B-12 Guidance on Crowdsourced Bathymetry

Chapter 2: Collecting Data

Discussion Topics

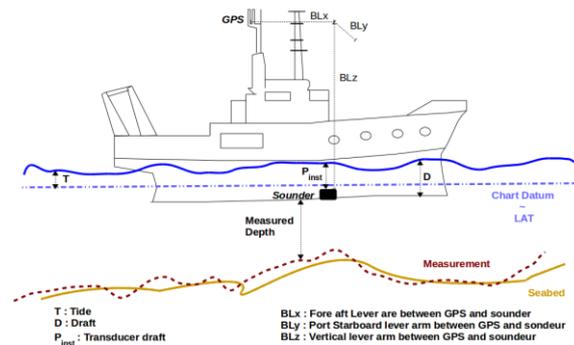
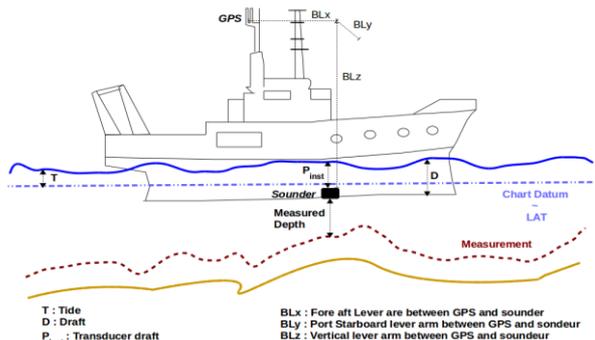
From: 2.3 Relative location of the sensor within the acquisition platform frame

Following figures to be added (originating from the uncertainty section) to describe more explicitly the consequences of poor relative measurements of the sensors

- Consensus
- Harmonisation of the Figure numbering
